October 28, 1996

Joseph M. Farley Nuclear Plant  
Verification of Seismic Adequacy of Mechanical and  
Electrical Equipment in Operating Reactors  
Unresolved Safety Issue (USI) A-46, Generic Letter 87-02 RAI Response

Farley Nuclear Plant - Unit 1  
USI A-46 Request for Additional Information

SKETCH 5-C  
125-V-DC Service Water Bldg Battery No. 1  
Equipment ID: QSR42B523A-A  
Scale 6'- 1'-0

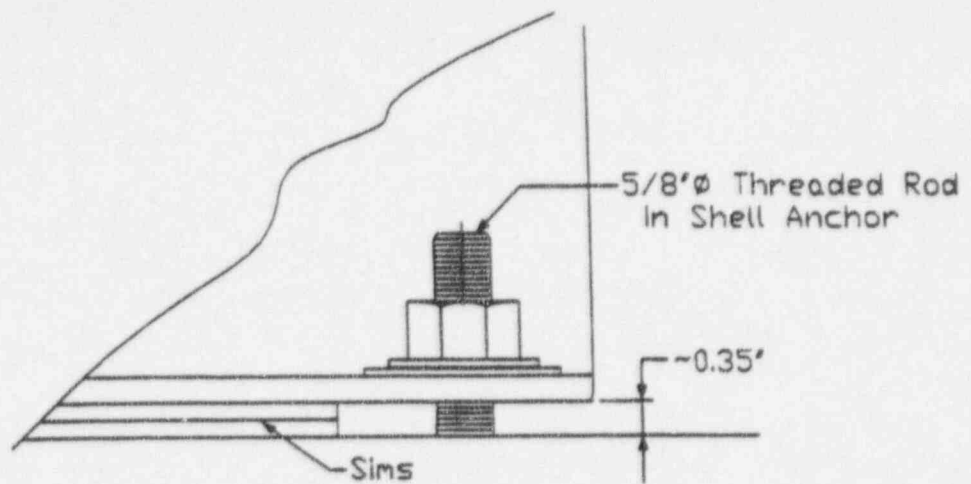
Appendix K contains few cases of outliers where potential bolt bending concerns were resolved by analysis. Provide the detailed analyses with sketches or drawings for the following three cases:

- a. LC Transformer in Diesel Generator Building (Equipment ID Q1R11B503-A)
- b. MCC 1K in Service Water Intake (EQ ID Q1R17B504-A)
- c. 125-V-dC Service Water Building Battery No. 1 (EQ ID QSR42B523A-A)

### c. 125-V-dc Service Water Building Battery No. 1 (Equipment ID: QSR42B523A-A):

Sketch 5-C of Figure 1 shows the largest gap found for this battery rack which is only about 0.4". This battery rack is a low height, two tier battery rack with 16 - 1/2" diameter Phillips Red Head anchors approximately 5-1/2" long. The maximum shear load on a bolt is only about 50 lb. and the maximum tensile load is less than 10 lb. due to the low aspect ratio of these racks. The extremely low resulting bending moment, and very low stresses/loads in the bolts, was the basis for determining that the anchorage is adequate.
